TECHNICAL BULLETIN

Hood Panel – Difficult to Latch/Contacts Plenum Grille – Reprofile Hood

76-109

MODEL XJS Range 1994-95 MY
VIN 190528 - 196254

ILLUSTRATION 1

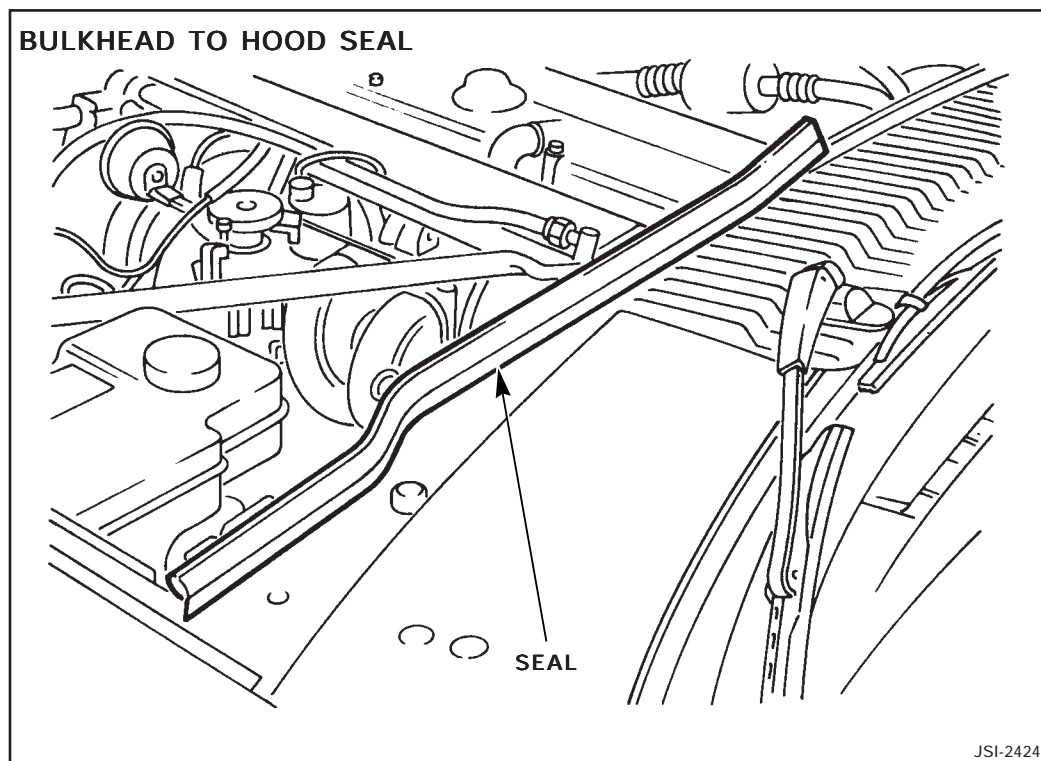
1. Remove and discard the rear bulkhead to hood seal, Illustration 1.

ILLUSTRATION 2

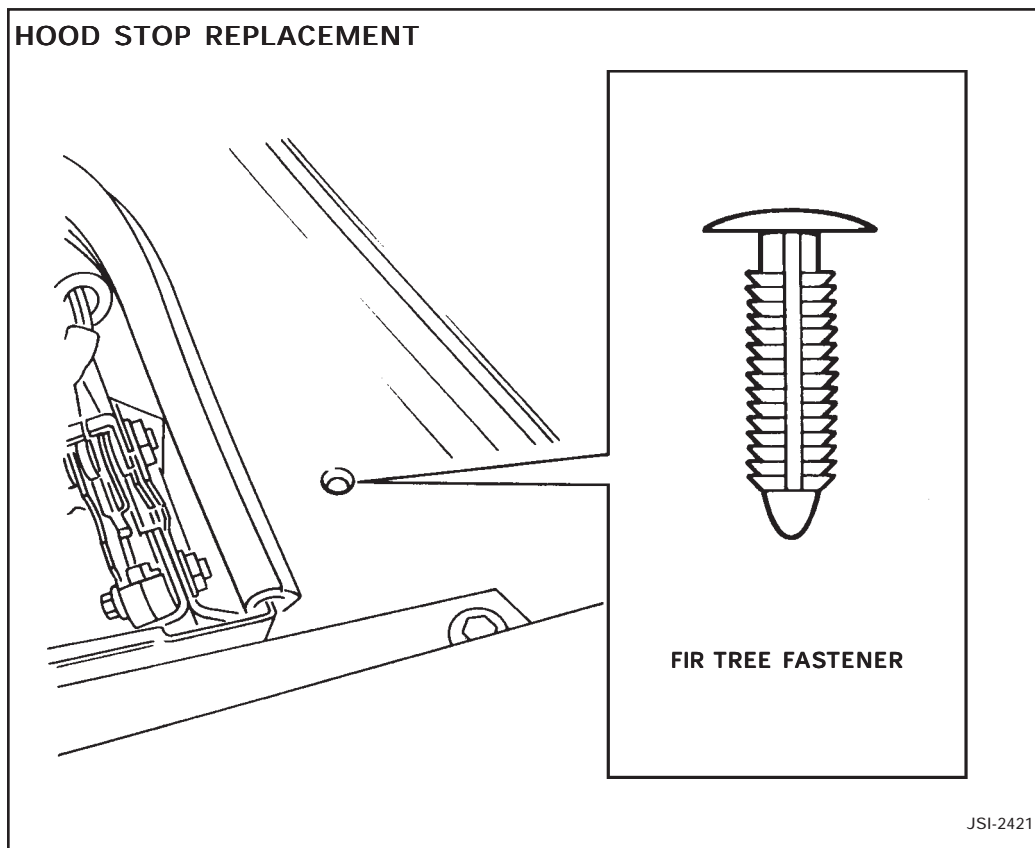
2. Remove and discard the hood stop buffers, mounting bolts, nuts, and washers. Apply a suitable sealer to the bolt holes and install fir tree fasteners, Illustration 2.
3. Cut two new hood seals to size and install on the engine compartment rear bulkhead ensuring that the joint of the seals is at the center line of the hood.

ILLUSTRATION 3

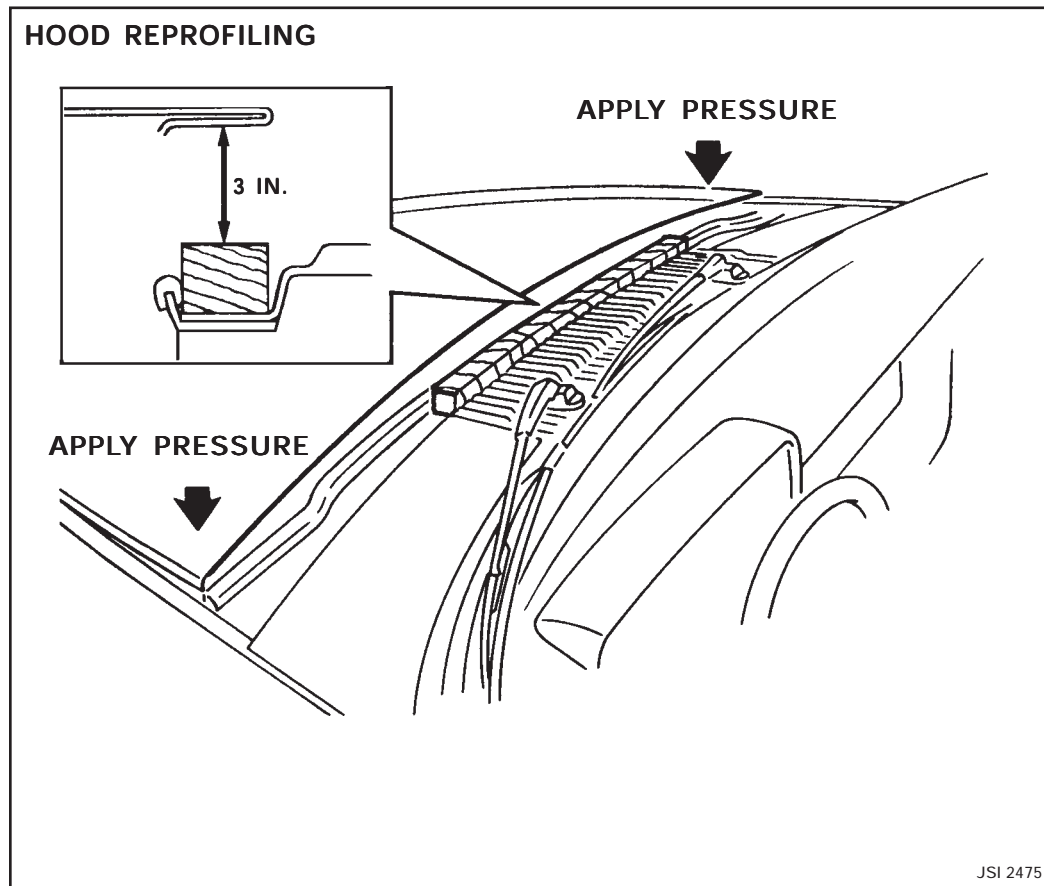
4. Obtain a suitable block of wood, Illustration 3, which will fit in the space between the bulkhead lip and the front edge of the plenum chamber. The block must be deep enough to rest on the drain channel and protrude above both edges. The block should be as long as the plenum grille to spread out the load.

7. Insert a suitable smooth object which will not damage the paint or the panel, such as a rubber mallet, between the hood panel and the wooden block to support the hood at a height of approximately 3 in. (7.5 cm), Illustration 3.

8. Apply pressure to the areas over the striker pins, Illustration 3, to modify the hood curvature and raise the center of the hood panel in relation to the sides.

ILLUSTRATION 4

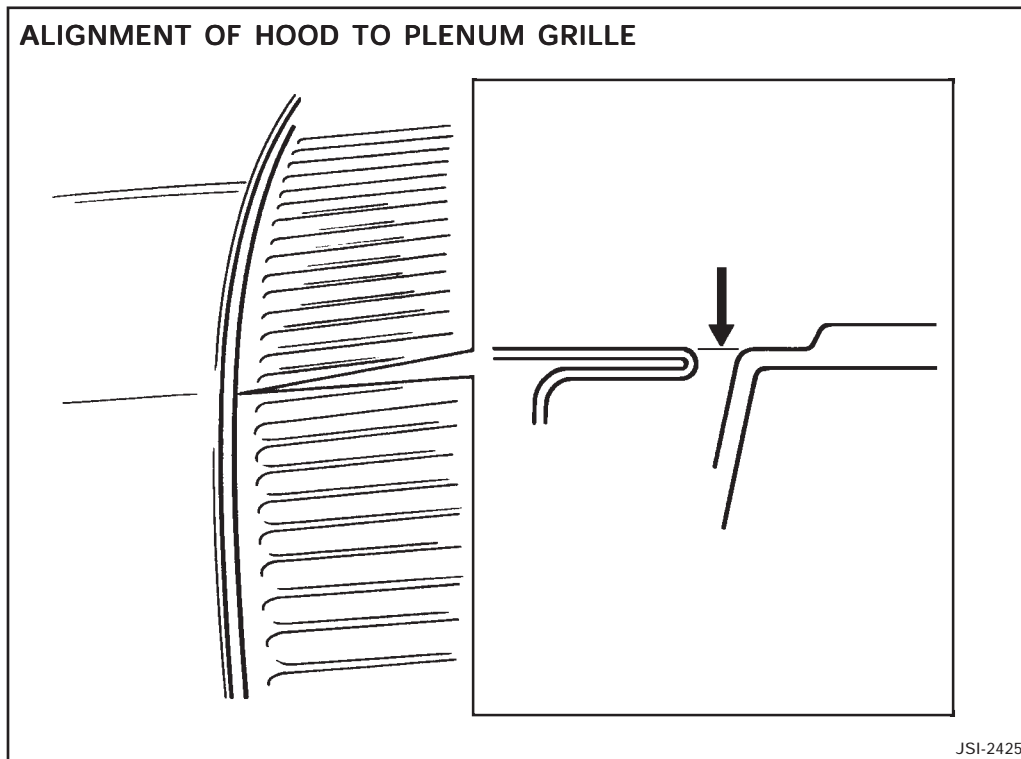
9. Check the fit of the hood to the body at the center, the plenum grille, (Illustration 4) and both outer edges.
10. Repeat the process until the hood profile matches the body profile.

ILLUSTRATION 5

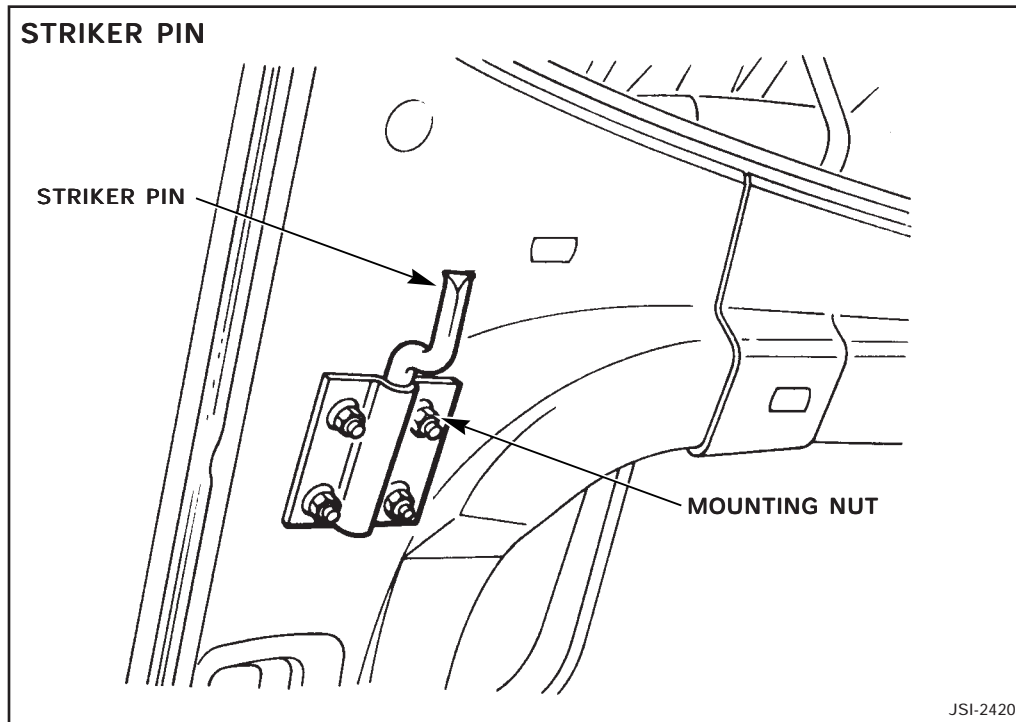
11. Loosen the nuts that secure the hood striker pins (Illustration 5) to allow some movement when the hood is closed.
12. Close the hood to check where the catches require adjustment.
13. Open the hood. Loosen the hood catch retaining bolts, reposition the catch assemblies and tighten the retaining bolts.
14. Check the hood position and tighten the striker pin mounting nuts.
15. Check striker and catch operation.
